Access Compliance Report

Public Rights-of-Way

(Curb Ramps)

Intersection ID: 11982	Main Street: MIDLAND_AV	Cross Street: SIMMONS_ST	Location:	N
ADA ID: F18BA89A875F	Ramp Type: BlendTrans1	Initial Pass/Fail: Fail	Overall Compliance: No	Severity Score: 8.75

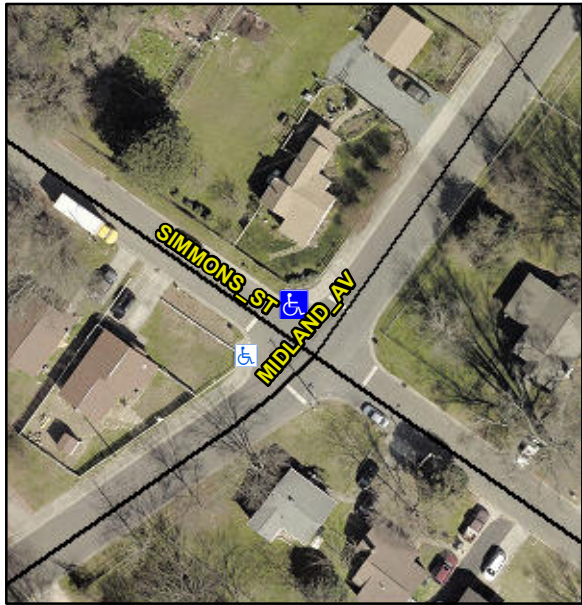
Codes/Mitigation Info/Possible Solution			Field Measurements/Component Compliance					
 <div>Street 1 NameSIMMONS ST</div> <div>Stop Condition-Street 1StopSign</div> <div>Street 2 NameN/A</div> <div>Stop Condition-Street 2N/A</div>	Possible Solutions:		Compliance	Description	Data	Compliance	Description	Data
	Remove & Replace Curb Ramp With Two New Directional Ramps or Equivalent.		N/A	Ramp Length (in)	73.0	Yes	BlendTrans Slope (%)	4.3
			No	Ramp Width (in)	45.0	Yes	BlendTrans XSlope (%)	1.2
			N/A	Flare Type LT	N/A	N/A	Flare Type RT	N/A
			N/A	Flare Slope LT (%)	N/A	N/A	Flare Slope RT (%)	N/A
			N/A	Flare Traversable LT?	N/A	N/A	Flare Traversable RT?	N/A
			N/A	Landing Length (in)	N/A	N/A	DWS Provided?	N/A
			N/A	Landing Width (in)	N/A	N/A	DWS Contrast?	N/A
			N/A	Landing Slope (%)	N/A	N/A	DWS Length (in)	N/A
			N/A	Landing X Slope (%)	N/A	N/A	DWS Full Width?	N/A
Surveyor Notes:		N/A	N/A	Landing Curb? (Y/N)	N/A	N/A	DWS Offset (in)	N/A

N/A	Shared Landing?	N/A				
PROW/ADA:		Not Found, R304.5.1	N/A	Gutter Ponding?	N/A	N/A	Gutter Slope (%)	N/A
			N/A	Gutter Lip Ht (in)	N/A	N/A	Gutter X Slope (%)	N/A
			N/A	Painted X Walk1?	No	N/A	Painted X Walk2?	N/A
				X Walk 1 Direction	To SW		X Walk 2 Direction	N/A
				X Walk 1 Width (in)	N/A		X Walk 2 Width (in)	N/A
				X Walk 1 Slope (%)	2.2		X Walk 2 Slope (%)	N/A
				X Walk 1 X Slope (%)	1.0		X Walk 2 X Slope (%)	N/A
			N/A	Ramp inside XWalk1?	N/A	N/A	Ramp inside XWalk2?	N/A
				Road Slope (%)	1.0		Clear Space?	N/A
				Road X Slope (%)	2.2	N/A	Clear Space to XWalk (in)	N/A
			N/A	Any Obstructions?	N/A	N/A	Storm Grate/Utility Hazard?	N/A
				Obstruction Type			Storm Grate/Utility Type	
					N/A			N/A
						Yes	Surface Condition? (G/P)	Good
						No	Curb Slope (%)	17.7
Total Cost:		\$ 3200.00
